**NC Department of Insurance
Office of the State Fire Marshal - Engineering Division
1202 Mail Service Center, Raleigh, NC 27699-1202
919-647-0000**

Dryer Duct Rated Assembly Membrane Penetrations

Code: 2018 NC Building Code
Section: 717.6.2

Code: 2018 NC Mechanical Code
Section: 504.2 & 607.6.2

**DRYER DUCT DETAIL
SECTION A**

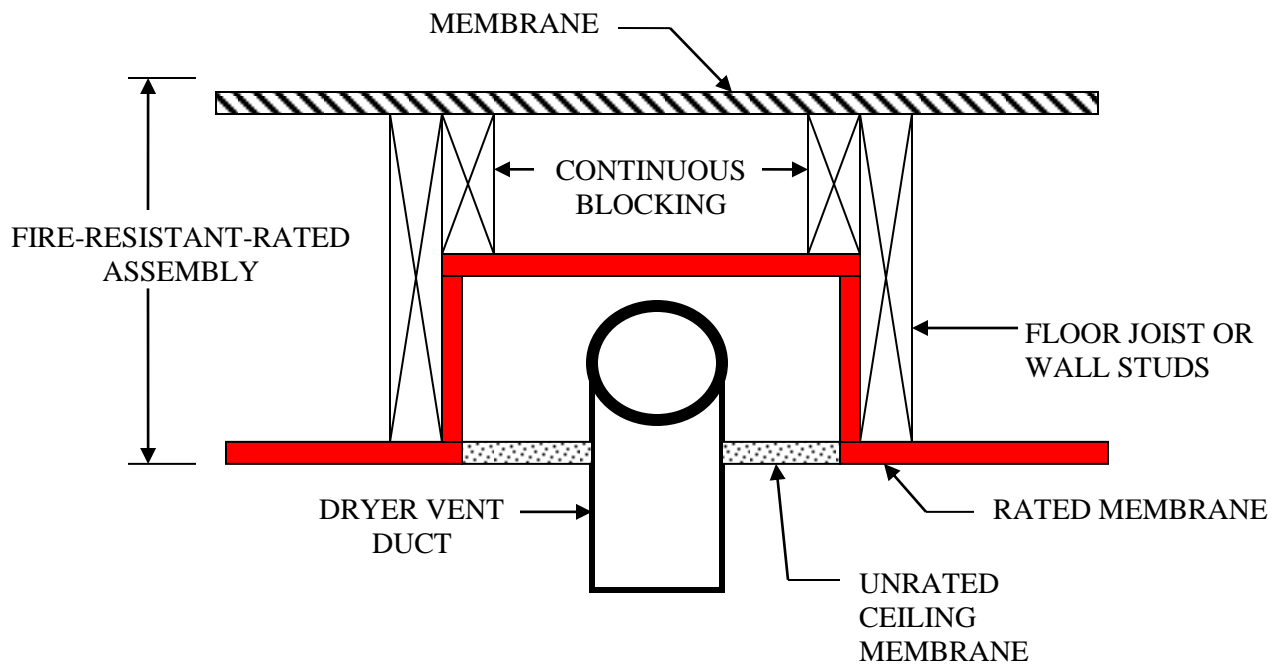
Since Section 504.2 of the NC Mechanical Code prohibits the placement of fire dampers and smoke dampers in dryer ducts, can a dryer duct penetrate the membrane of a rated floor/ceiling, roof/ceiling, or wall assembly?

- 1) The duct can be wrapped with rated duct wrap from the point that the duct enters the rated assembly to the point where it leaves the rated assembly (see Section A). The duct wrap must be listed and labeled for the specific intended use. The duct wrap must be rated the same as the floor/ceiling assembly, roof/ceiling, or wall assembly. The penetration must be sealed to prevent the passage of smoke or flame.
